STAFF RECOMMENDATION
1203 Forrest Avenue
April 18, 2012

Application: New construction—addition
District: Lockeland Springs-East End Neighborhood Conservation Zoning Overlay
Council District: 06
Map and Parcel Number: 08309009400
Applicant: David Baird, architect
Project Lead: Melissa Baldock, melissa.baldock@nashville.gov

1203 FORREST AVENUE RENOVATION AND ADDITION

NEW CONSTRUCTION
ELEVATIONS

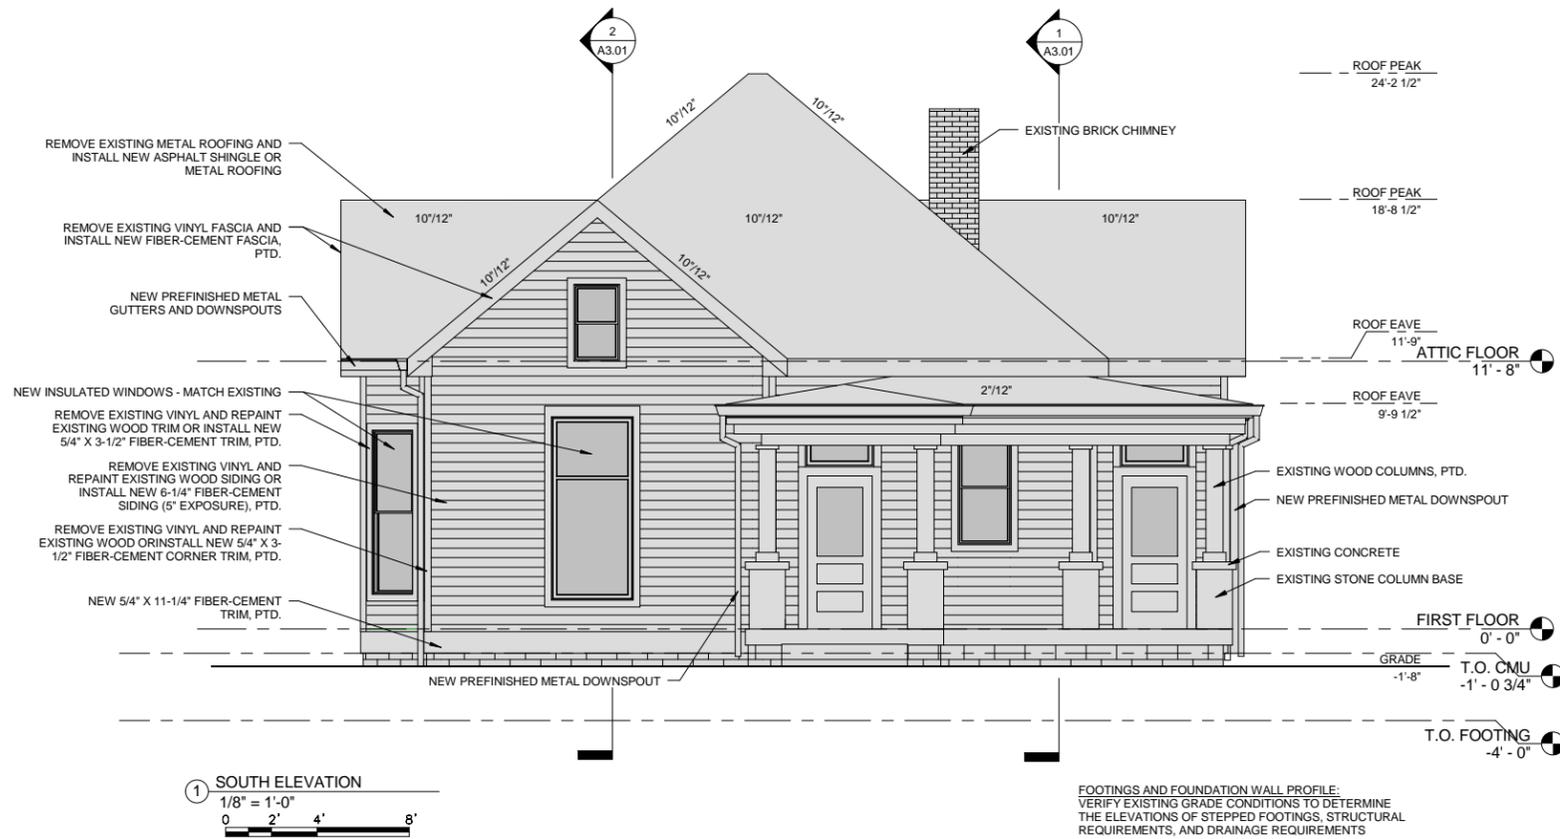
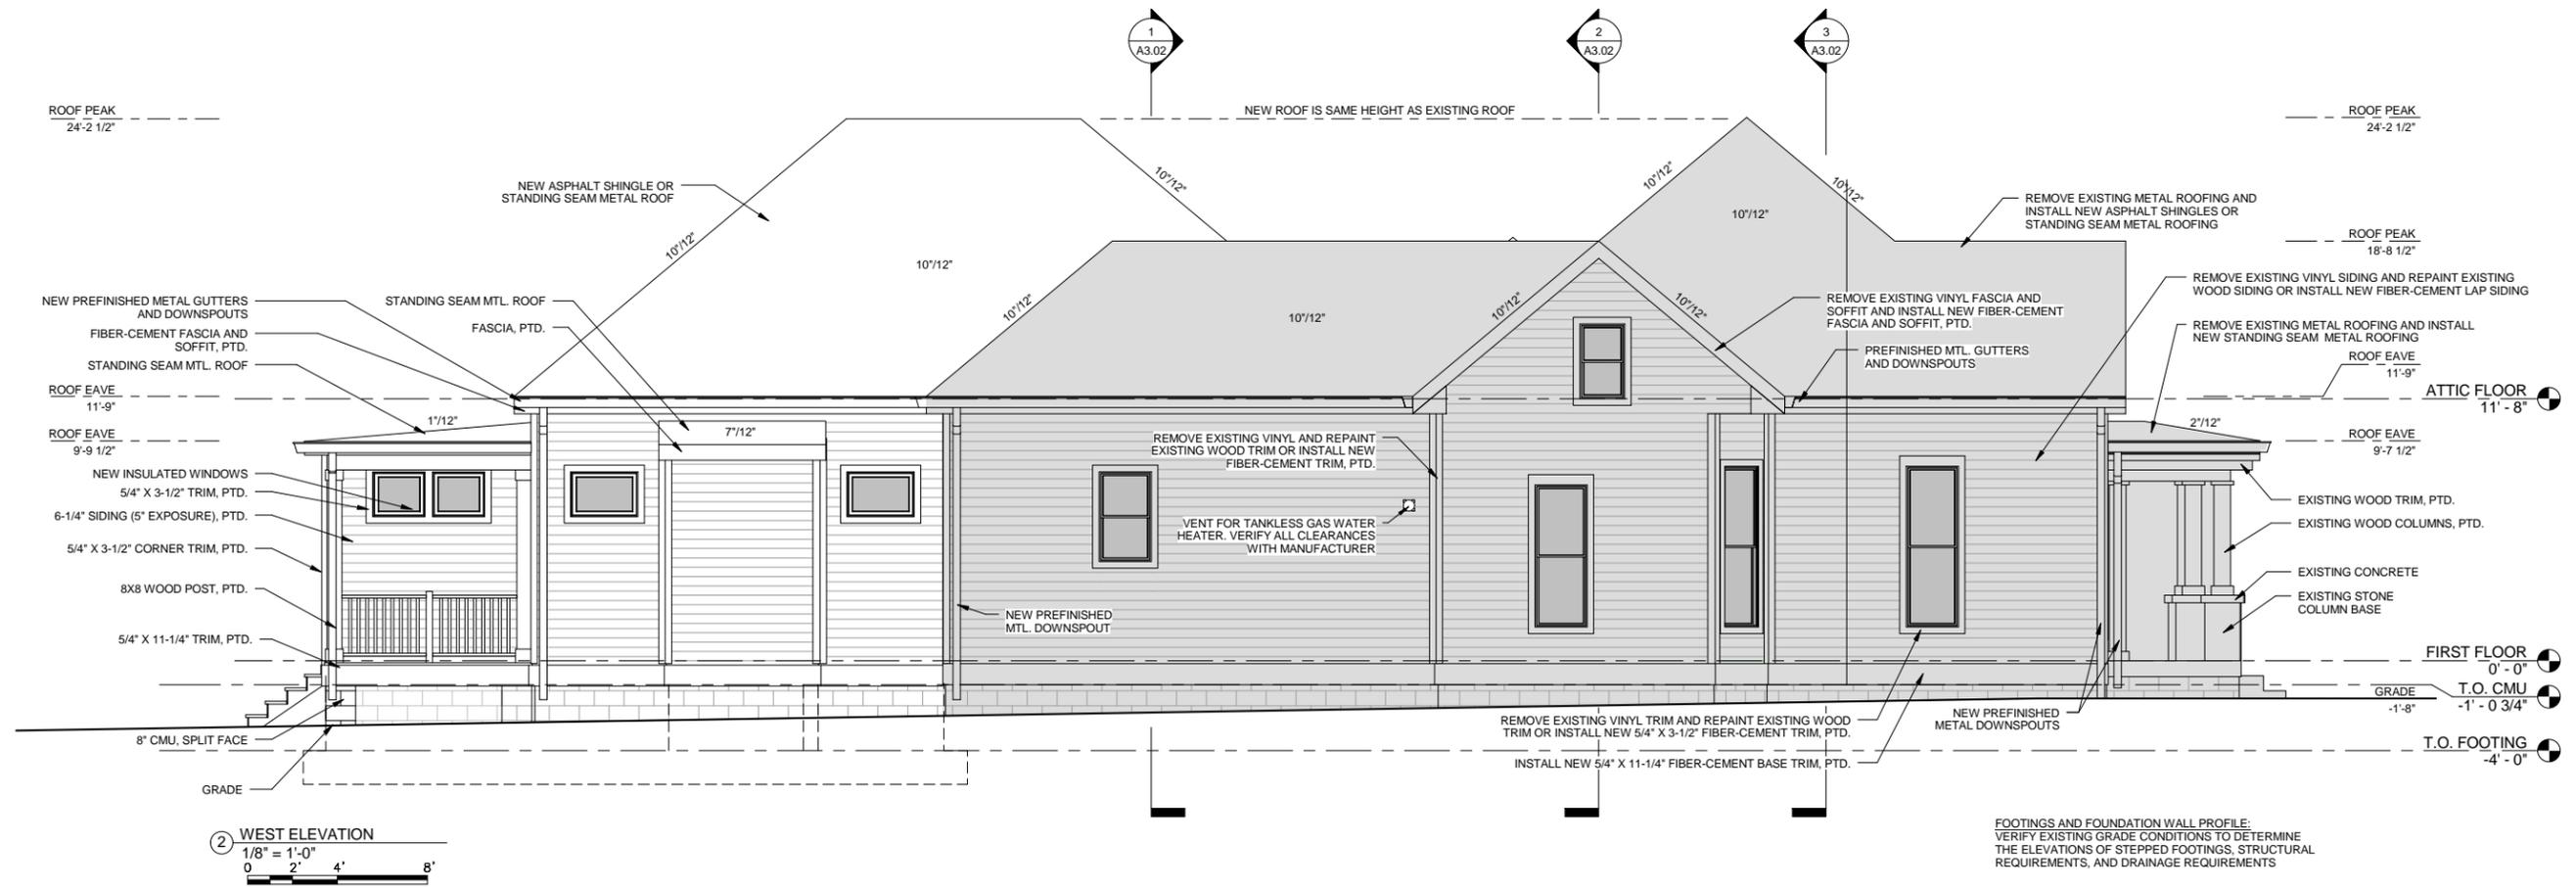
Height & Scale: The maximum ridge height of the addition will match the maximum height of the historic house, which is approximately twenty-six feet (26'). In addition, the addition's ridge height is separated from the ridge height of the house by approximately twenty-nine feet, eight inches (29'8") of linear space, helping to preserve the historic house's roof form and distinguishing the old from the new. The addition's eave height and foundation height will also match that of the historic house.

Roof: The historic house has a complicated Victorian roof form. The front and the side facades have cross-gables with a roof slope of 10/12. The main portion of the roof is a hipped roof form with a slope of 10/12, and at the rear is a historic addition with a 10/12 gabled form. The front porch's slope is 2/12. The applicant's design preserves the majority of the historic roof form and ties into it appropriately. The only portion of the existing roof that will be lost once the new addition is built is the interior slope of the historic addition, which staff finds appropriate.

The main roof form of the addition is a hipped roof with a 10/12 slope. A cricket with a slope of 2/12 will be inserted where the addition ties into the back of a historic roof and will help separate the addition from the historic house. A lower portion of the addition with a slope of 1/12 will encircle the right and rear facades of the addition. On the left façade, the bay will have a roof slope of 7/12.

Proportion and Rhythm of Openings: No changes will be made to the window openings on the historic house. On the addition, staff finds that there are no large expanses of wall space without a door or window opening and that the window sizes and proportions are appropriate for an addition. Staff therefore finds the project's proportion and rhythm of openings to meet Section II.B.7. and II.B.10. of the *Lockeland Springs-East End Neighborhood Conservation Zoning Overlay: Handbook and Design Guidelines*.

Materials, Texture, and Details and Material Color: The applicant will be removing the existing vinyl siding from the historic house, and will be restoring the wood siding underneath, if possible. If repairing the siding is not possible, then the siding will be replaced with cement fiberboard siding. The addition will be clad in cement fiberboard with a five inch (5") reveal.

The existing metal roof on the historic house will be removed. The historic house and the addition will be re-roofed with either asphalt shingle or standing seam metal. The front porch, the addition's bay, and the addition's lower 1/12 roof form will all have standing seam metal roofs. The windows on the historic house will be replaced with windows of the same size. (Roof material and window replacement on existing buildings is not reviewed in Neighborhood Conservation Zoning Overlays.) The materials for the windows on the addition were not specified, and staff asks to review and approve the window and door materials and specifications prior to purchase and installation. The rear porch columns will be wood posts. Staff asks to review and approve the front and rear porch railings' design and materials. The foundation will be split face concrete block.

Staff recommends approval of the application with condition that staff review and approve the roof color, front and rear porch railing material and design, and window and door materials and specifications.
